**DEPARTMENT OF PLANNING AND
COMMUNITY DEVELOPMENT**

ACTION DATE: May 19, 2011

CASE NOS.: 10-ZC-003, 10-SPR-004, 10-SP-048 and 10-VAR-005

LOCATION: 28898 Canwood Drive (A.P.N. 2048-011-034)

SUBJECT: In-N-Out Burger Site Plan Review

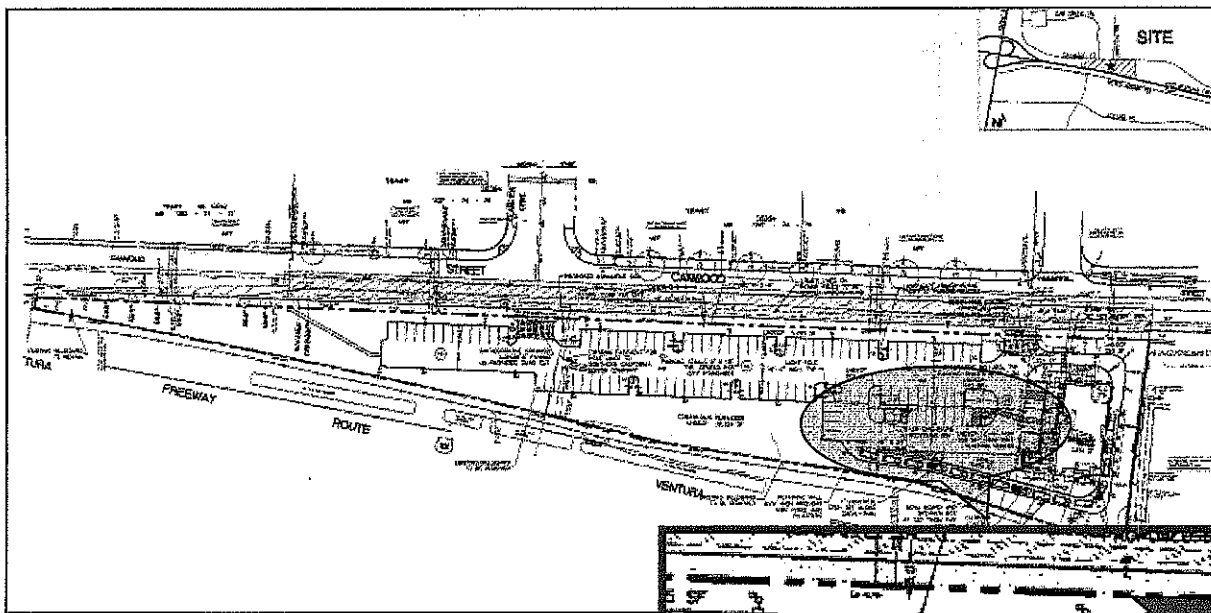
Mike Kamino, Director of Community Development, and I have reviewed the proposed site plan for In-N-Out burger and request the following changes to be made to further improve the on-site circulation and access.

1. The drive-thru storage space can currently accommodate 15 cars. The revised traffic study report includes actual queue data from two existing In-N-Out locations – one in Newbury Park and the other in City of Moorpark. Based upon this data, the revised queuing analysis indicates that an average of 8-10 vehicles would be expected in the queue with a maximum of 16-20 vehicles during peak times. Therefore, it is recommended that the drive-thru storage be modified to include adequate storage space for at least 20 vehicles. This will result in eliminating about 4-6 on-site parking spaces.

2. The site plan currently shows parking stalls adjacent to the restaurant pad and two aisles with three rows of parking located west of the restaurant pad. The drive-thru also terminates at the entrance of the easterly driveway. This layout is expected to result in a lot of vehicular activity in the space identified as 'A' in the attached mark-up. To improve the circulation in this area and to remove any potential conflict points, it is recommended that the:

**Proposed revisions to
 the parking layout
 and
 proposed signage**

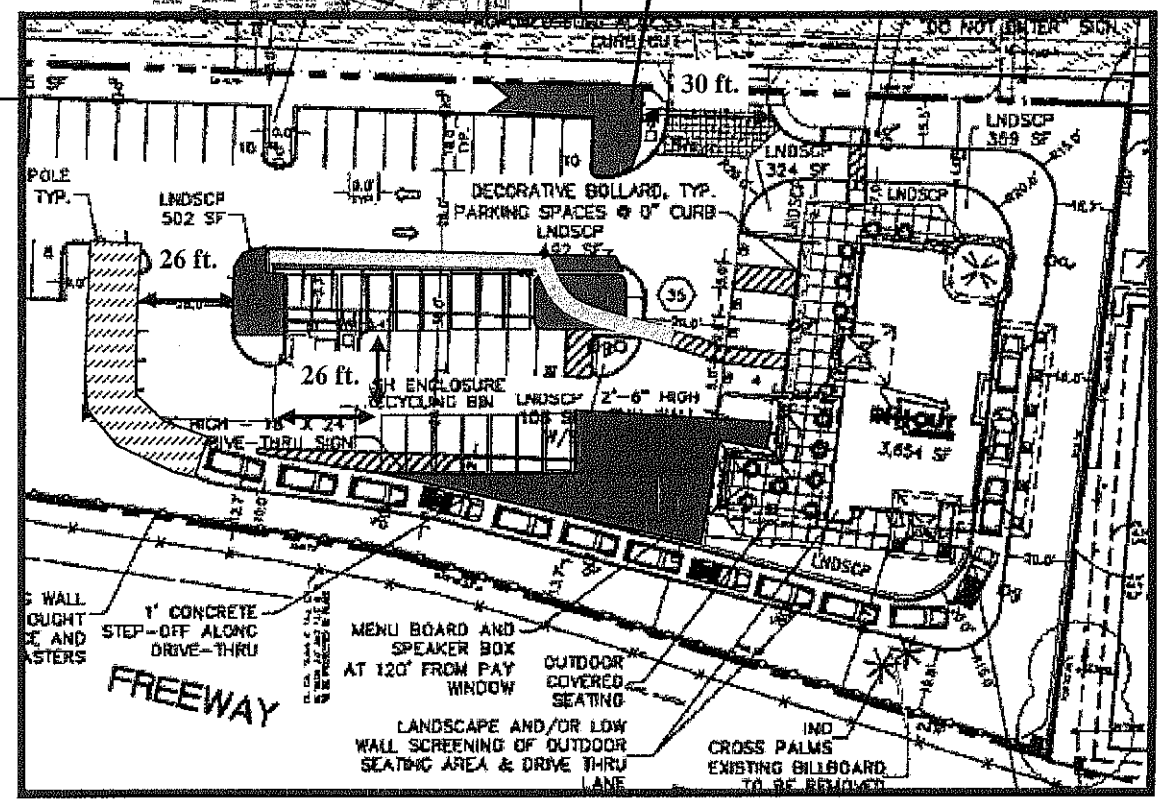
-  New Landscape Planters
-  Relocated Parking Spaces
-  New Striping
-  New Dedicated Sidewalk
-  New Signage
